Appendix A Design Update 01, February 2025

Design Update Request/Notification

FORM A – SUMMARY OF REQUEST/NOTIFICATION			
Project:	The Medworth Energy from Waste Combined Heat and Power Facility Order 2024 Made: 20 February 2024		
Reference:	CP3_R2_DU01		
Originator:	Medworth CHP Limited (the Developer)		
Name:	Tim Marks	Position:	Head of Planning
Issued to:	Cambridgeshire County Council	Date issued:	05/12/2024

EfW CHP Facility Design Update 01

Appendix B
EFW CHP Facility Horizontal Limits of Deviation

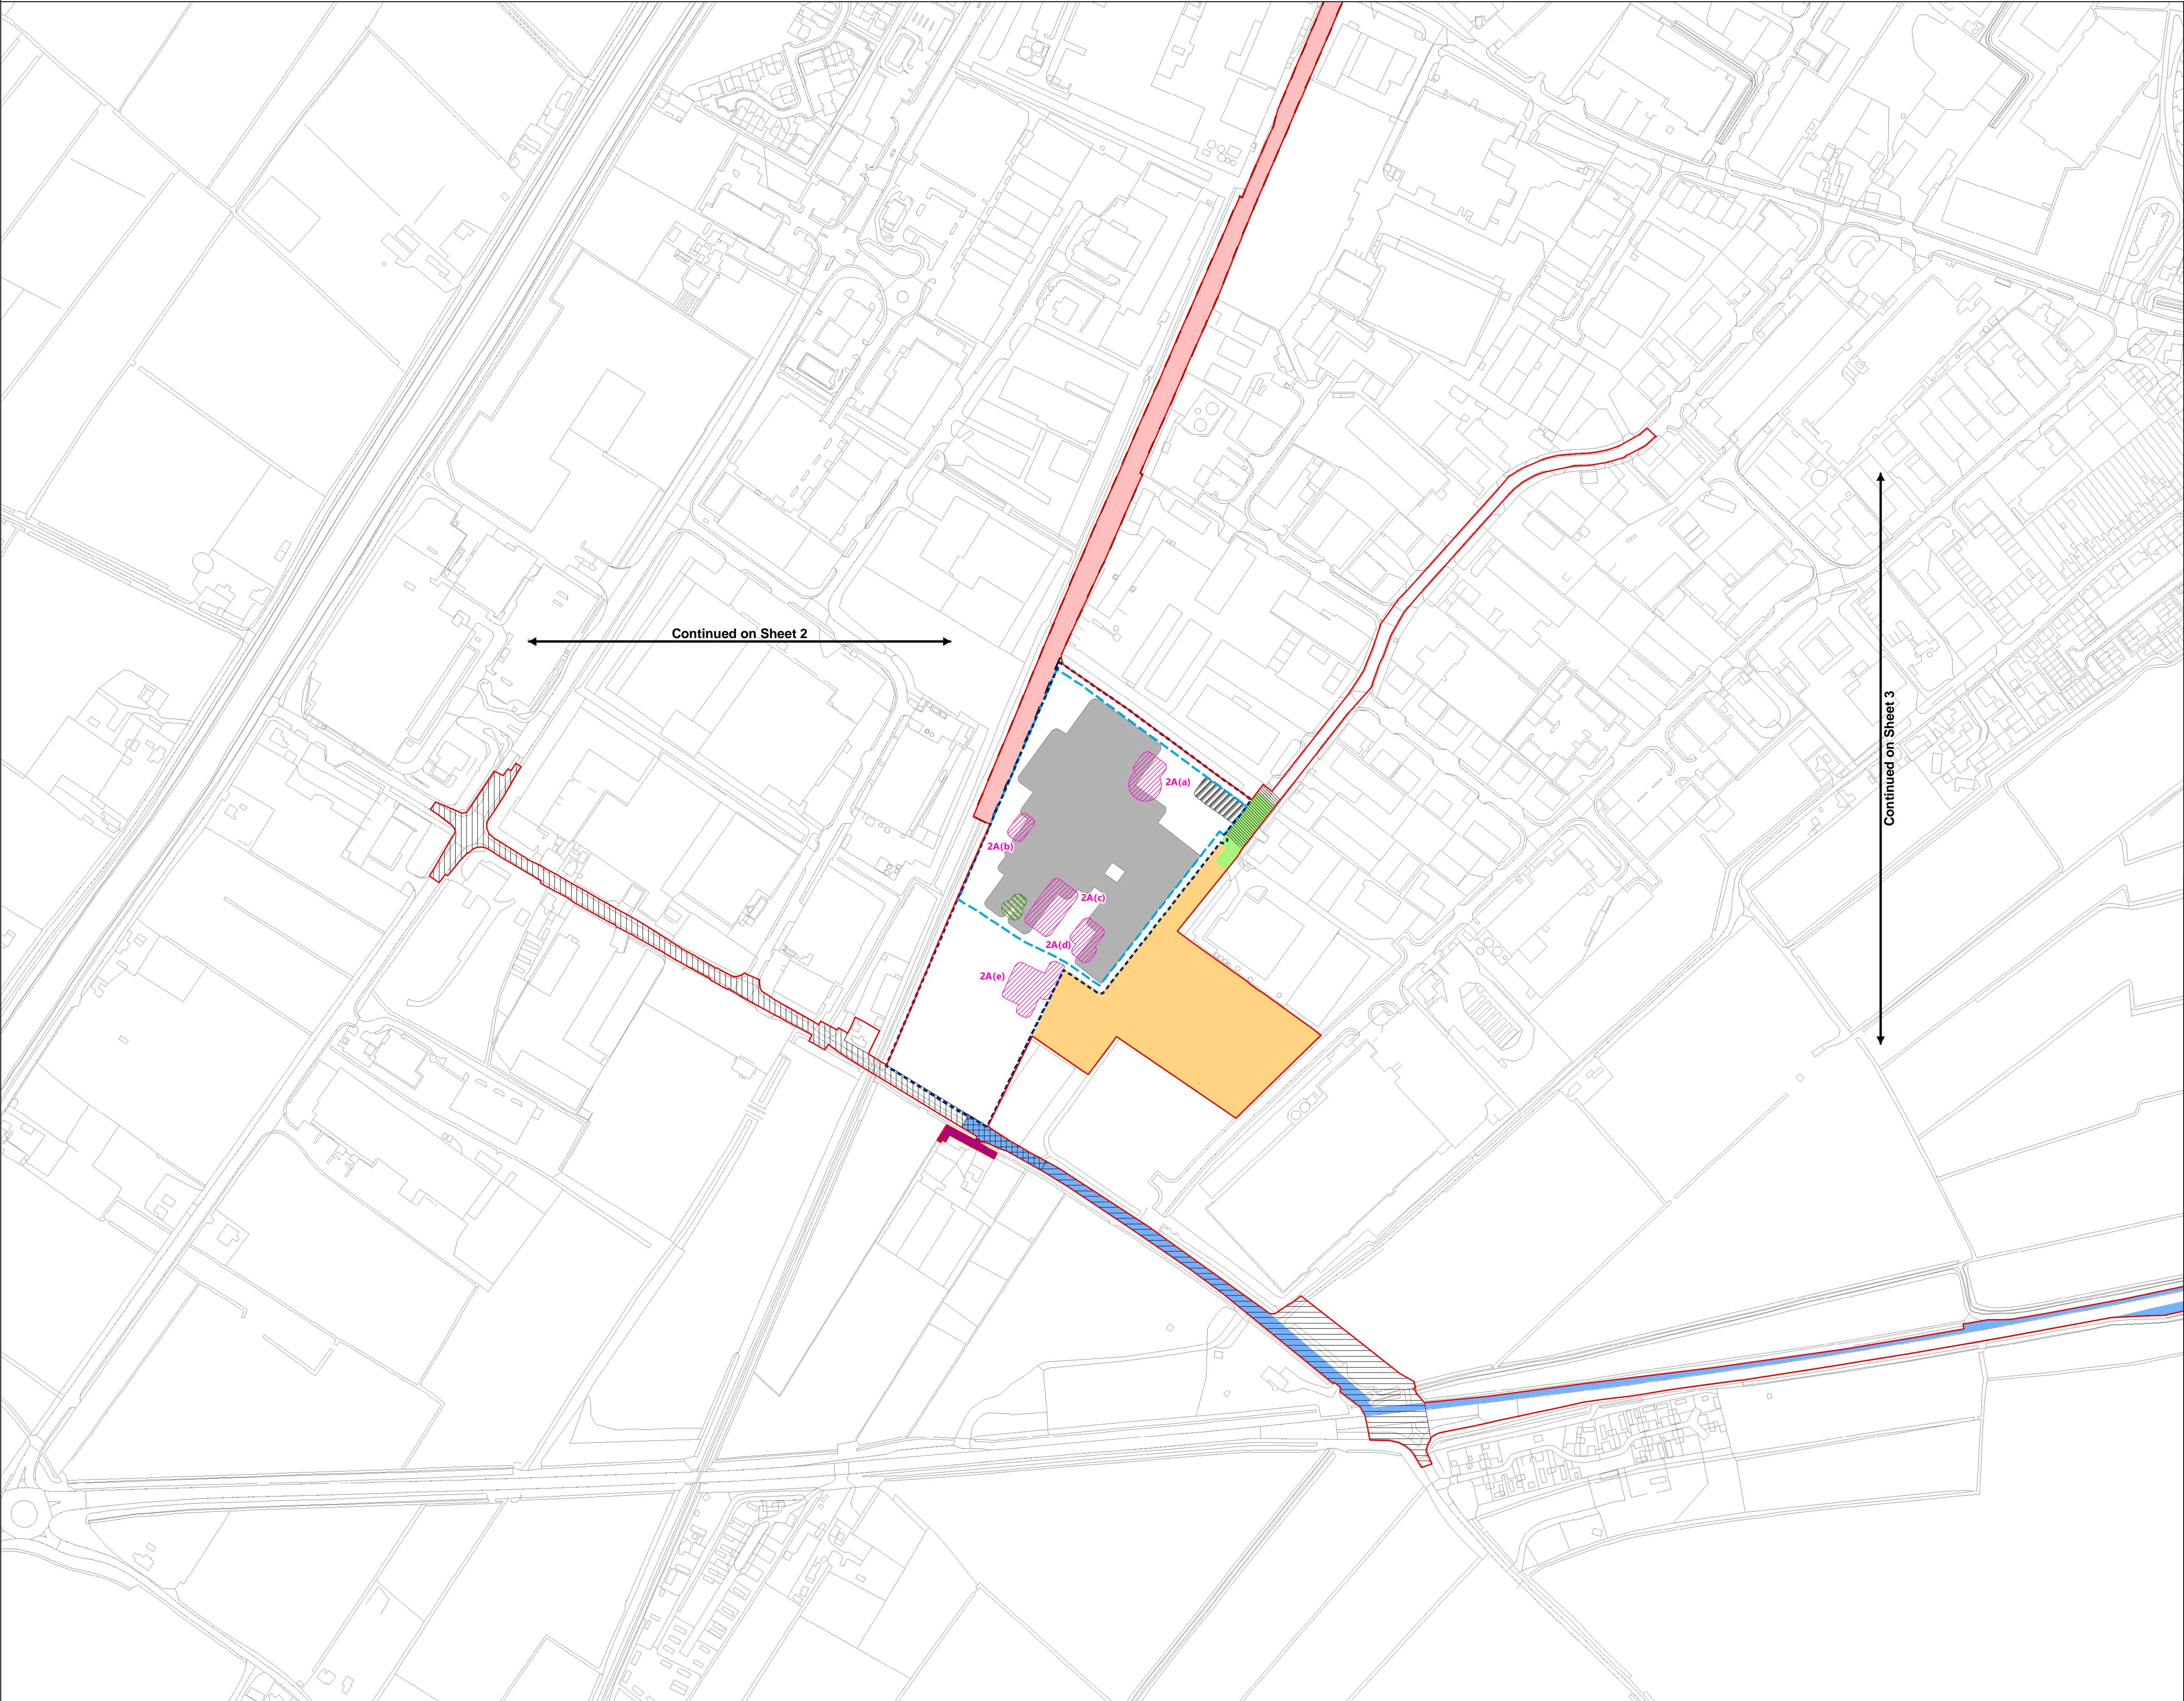
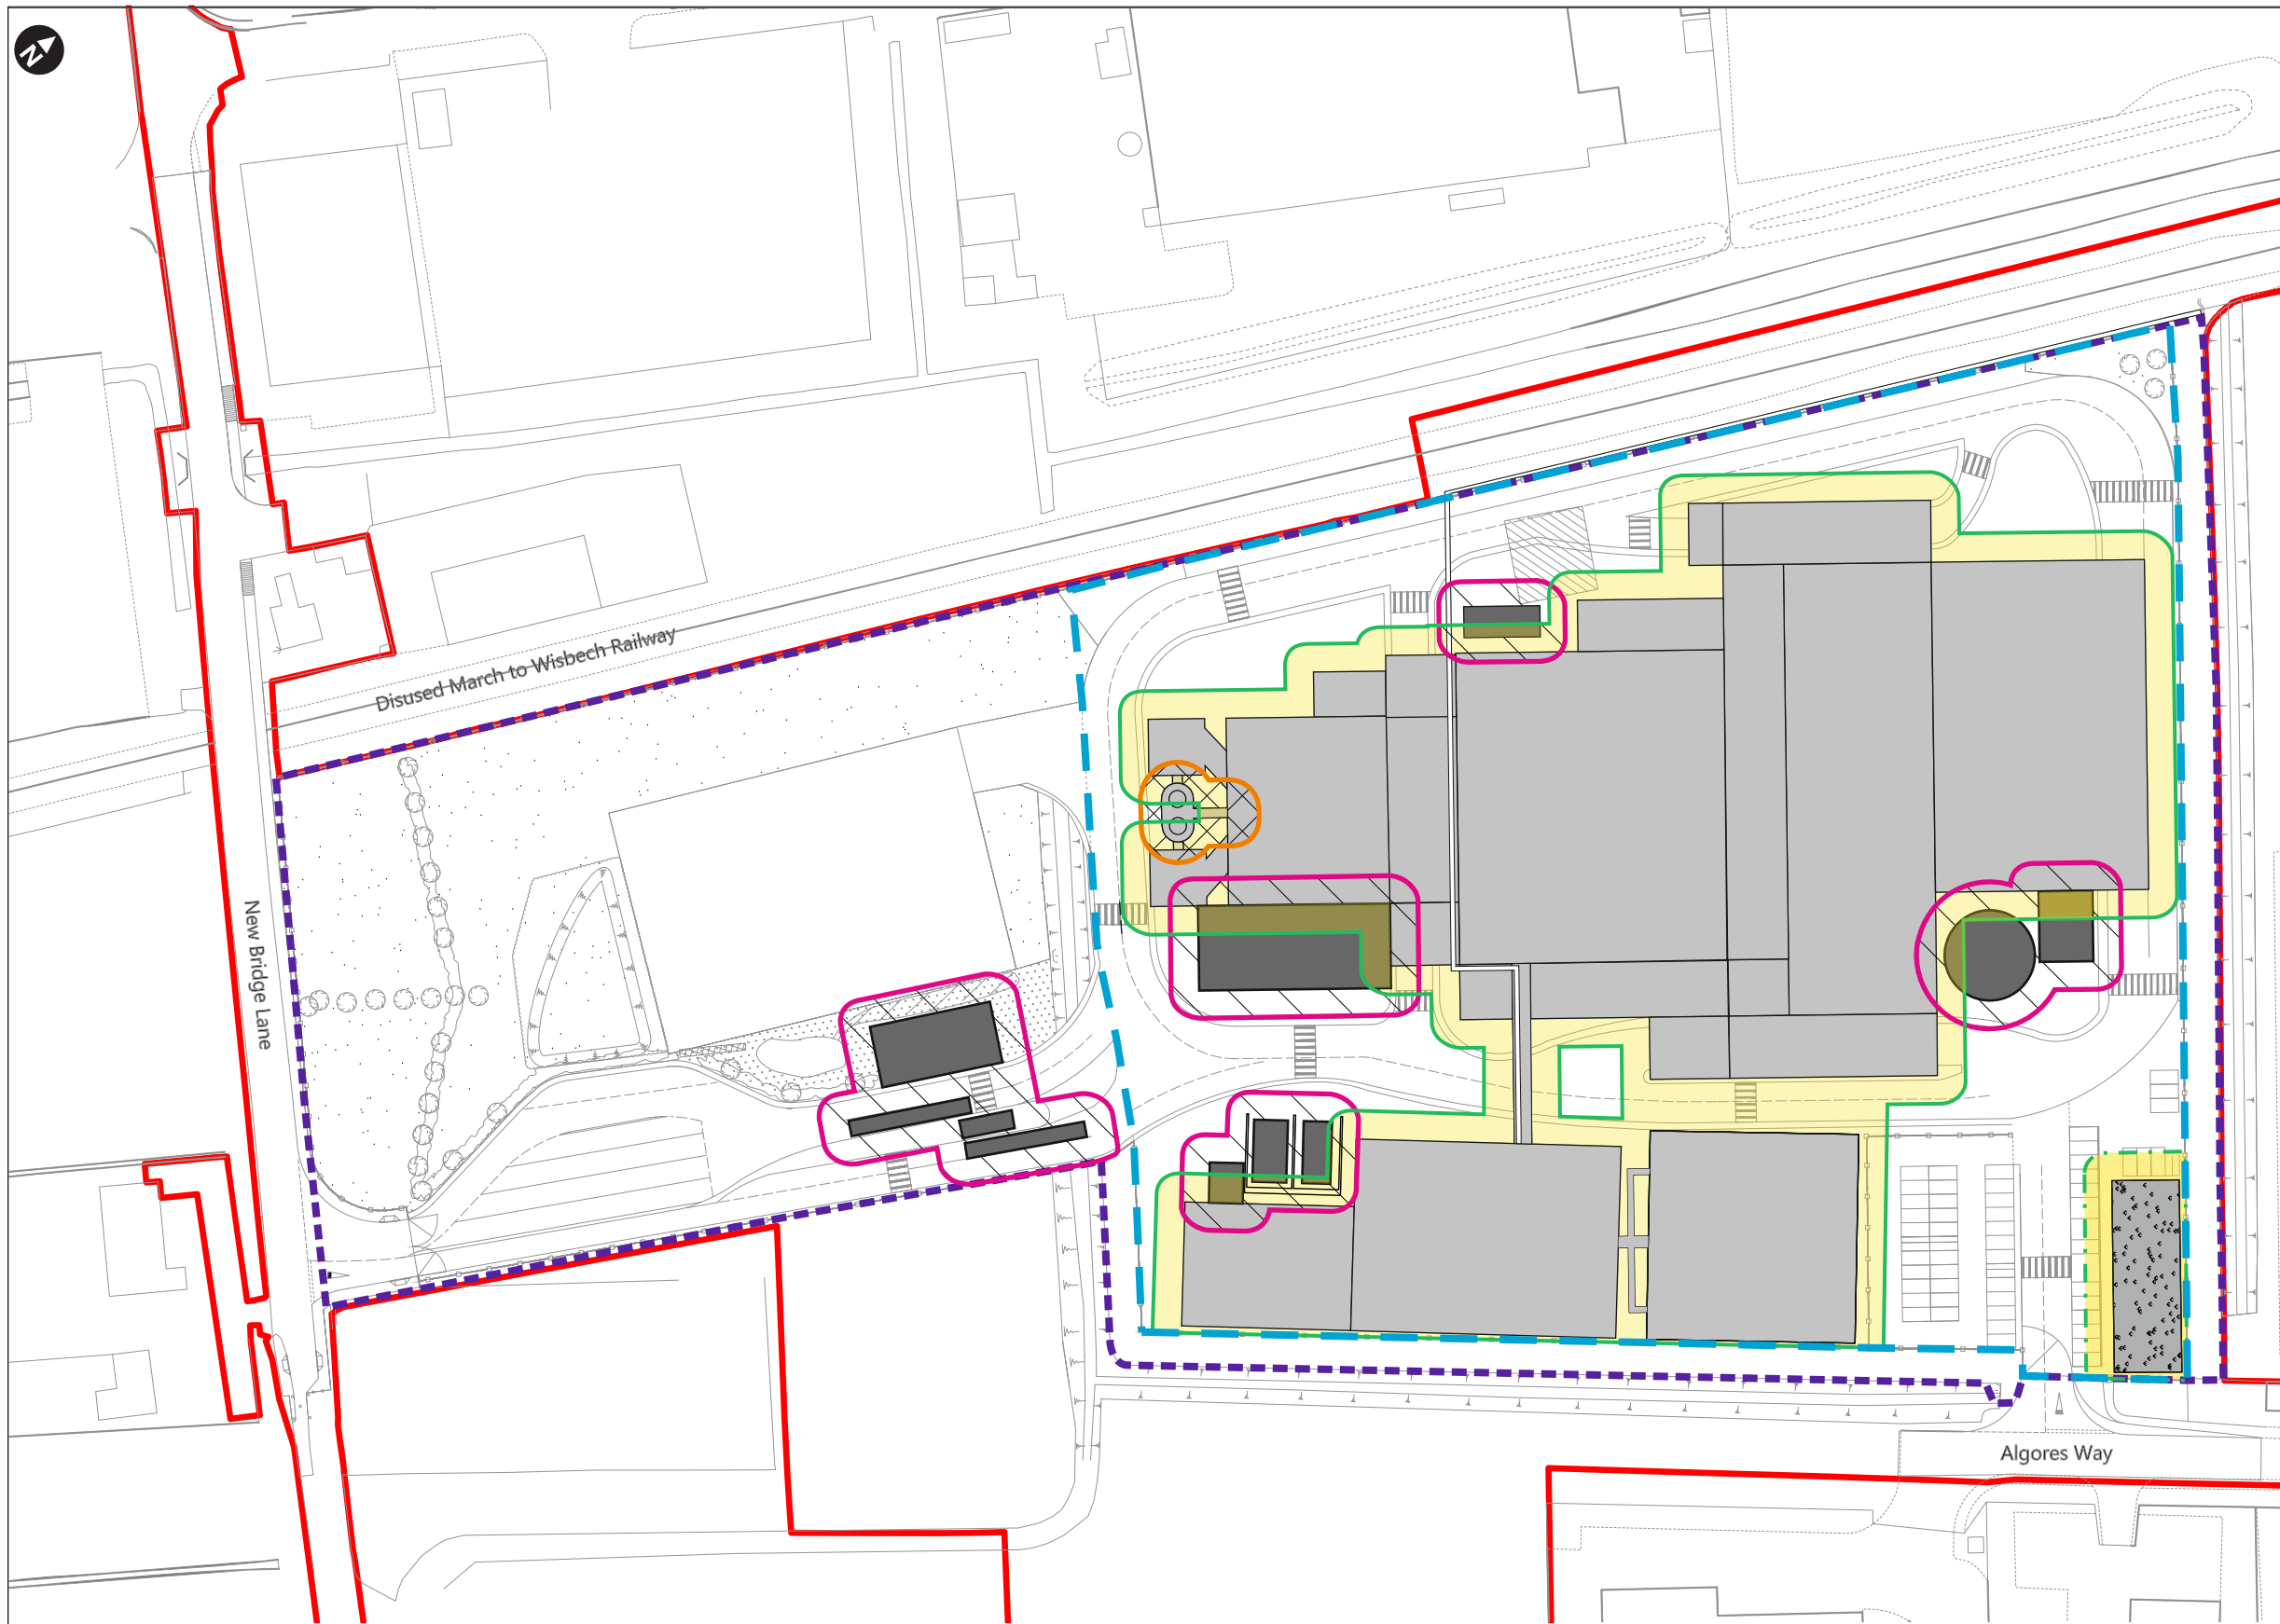
Work No.1 building and structures are within the horizontal limits of deviation

Work No.1A (chimneys) are within the horizontal limits of deviation. Note: CEMS platform to be confirmed at a later design review

Work No.2A (workshop/store) is within the horizontal limits of deviation. Note: other components of Work No.2A to be confirmed at a later design review
